North – South Commuter Railway (NSCR) Project (Malolos – Tutuban) Package CP02: Elevated Structures and 3 Stations			
ITEM NO.	REFERENCE CLAUSE/ SECTION	CLARIFICATION REQUEST	RESPONSE
Volume II, Part 2 – Work Requirements			
TS 400			
1	Page TS400-455, Clause 555.1.3, Specifications (Signages)	<p><u>Reference:</u> "Signs shall be designed in accordance with the relevant and applicable sections of the BNBC:"</p> <p>As specified in TS455, BNBC shall be used for the design of the signages. We proposed to use the applicable code/standard in the Philippines.</p>	Yes, the Bidder's proposal is acceptable.
TS 500			
2	Pages TS500-212 and TS500-219, Clause 522 Aluminum Composite Material	522.1.4 (Product Composition and Material Properties) indicates that skin material thickness is 0.5mm, while 522.3.2 (Material) indicates that thickness is 0.3mm. Please confirm which clause no. will govern.	The skin material thickness for the Aluminum Composite Material shall be 0.5mm thk. as indicated in TS 500, Clause 522.1.4.

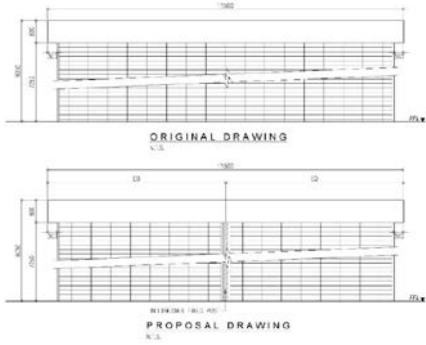
13	Pages CP02-B2-027	Please provide the following information for Maintenance	The maintenance catwalk mentioned in Volume IA, BOQ,

North – South Commuter Railway (NSCR) Project (Malolos – Tutuban) Package CP02: Elevated Structures and 3 Stations			
ITEM NO.	REFERENCE CLAUSE/ SECTION	CLARIFICATION REQUEST	RESPONSE
	to 028; CP02-B2-264 to 265; CP02-B2-524 to CP02-B2-525, Reflected Ceiling Plan and Details (all stations)	Catwalk mentioned in BOQ no. 3, pages 37, 54 and 71, item no. 411(2): 1. Please confirm if the maintenance catwalk is designed for pedestrian loading only. 2. Structural steel support/bracing details	BOQNo.3 in Pages BOQ-37,BOQ-54andBOQ-71,Itemno.411(2) is only for maintenance use of the staff. For other details needed, the Contractor shall submit shop drawings to the Engineer for approval prior to start of works.
14	Page CP02-B2-033, Balagtas Station Architectural - Architectural Plan Concourse And Platform Level	Floor finish for Trash Room specified in floor pattern layout (NSCR- DWG-BAL-AR-3181) is 900x900x12mm thk. Non-skid granite, while in Schedule of Finishes (NSCR-DWG-BAL-AR-3201) it is self levelling epoxy. Please confirm which is correct.	Please follow PageCP02-B2-036, Drawing No. NSCR-DWG-BAL-AR-3201 Schedule of Finishes that indicates Self Levelling Epoxy Paint with Hardener. This applies to all Stations.
